MEMORANDUM

TO:	Planning and Zoning Commission
FROM:	Morgan Landers, AICP – Consulting Planner
DATE:	August 6, 2026
RE:	Priority Code Updates – Ordinance 1279

ORDINANCE 1279

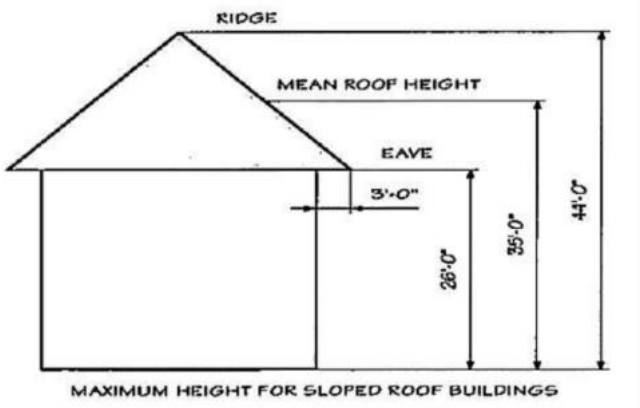
Roof Pitch Incentive - The current code allows buildings in the T, T-3000, T-4000, and GR-H zone districts to extend up to 44ft if the roof pitch is greater than 5:12. See the image below for a graphic of how this is calculated. The purpose of this provision is to encourage the use of pitched roofs in higher density multi-family developments. Reflecting on current architectural trends, the common roof forms seen in new developments are flat roofs. Therefore, the draft ordinance reduces the applicable roof pitch to 3:12 and reduces the total height increase to three feet above the maximum building height per the zone district. This provision, in conjunction with a reduction in maximum building height will encourage the use of varied roof forms.

Figure 08-2: Building Height Calculation

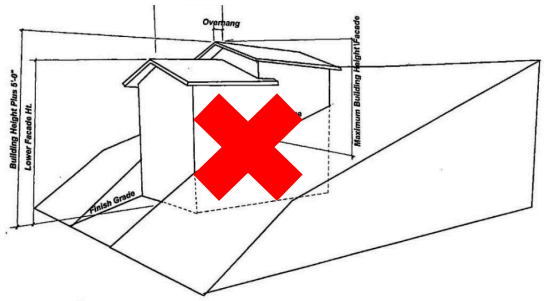
Building Height Definition - The draft ordinance also amends the building height definition to remove the 5ft height bonus, and required facade setback of 50%, for developments that step up hillsides and removes a section of the overall definition related to a secondary measurement of points not in vertical alignment. The goal of this revision was to further restrict heights in the Mountain Overlay and to simplify how building height is calculated.

1. In all other Districts:
   a. Building height shall be the greatest vertical distance measured at any point from natural, existing, or finished grade, whichever is lowest, to the highest point of the roof. ~~The maximum vertical distance from the lowest exposed finished floor to the highest point of the roof (regardless of vertical alignment) shall be no more than five feet greater than the maximum height permitted in the zoning district.~~ No facade shall be greater than the maximum height permitted in the zoning district or overlay district.

b. Facades that step up or down hillsides shall be set back from the lower facade a minimum of 50 percent of the height of the lower facade; except, that roof overhangs may extend up to three feet into this area. This building height provision shall apply to parapets, Boston roofs and any other portion of a building roof, but shall not apply to flagpoles, lightning rods, weathervanes, antennas, or chimneys.

> *"Building Height shall be the greatest vertical distance measured at the lowest point of natural, existing or lowest exposed finished grade along the building foundation perimeter to the highest point of the roof regardless of vertical alignment."*

> *"One-third (1/3) of a building's or structure's total roof area may exceed maximum building height by five feet. Setbacks shall be calculated based on the total building height."*
